ATTACHMENT C

**Re: Permit Requirement for Stack Merger Project
Mirant Potomac River Generating Station, Alexandria, Virginia**

**Re: New Source Review (NSR) Permit for Construction of Stack Merger and
Comprehensive State Operating Permit for Mirant Potomac River
Generating Station, Alexandria, Virginia**

**Re: Comprehensive State Operating Permit (2 Stack Version) for Mirant
Potomac River Generating Station, Alexandria, Virginia**

Daily Average PM2.5 Levels at Marina Towers and at Fairfax County's Annandale Monitor* - April 11 - June 12 2007

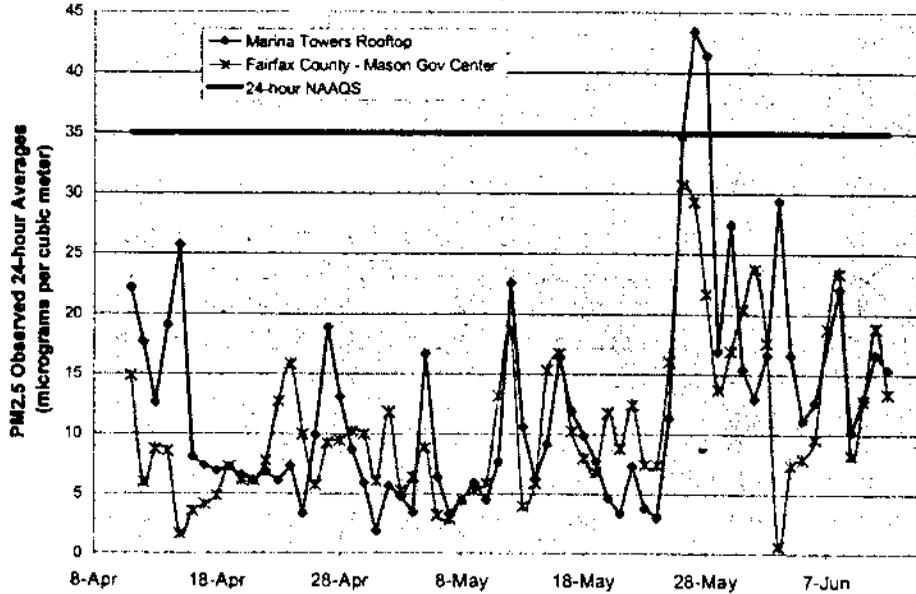
Alexandria has also collected several months of ambient PM_{2.5} data at the roof of Marina Towers during 2007. The following chart is a summary of the monitored concentrations, along with simultaneous data from a regional monitor. The table below shows more detailed monitoring data during three days in May 2007 when concentrations at Marina Towers approached or exceeded NAAQS. The data shows that concentrations at Marina Towers often exceed the regional values and in some cases exceed the NAAQS level. These data further enforce the need to evaluate PM_{2.5} emissions from the PRGS.
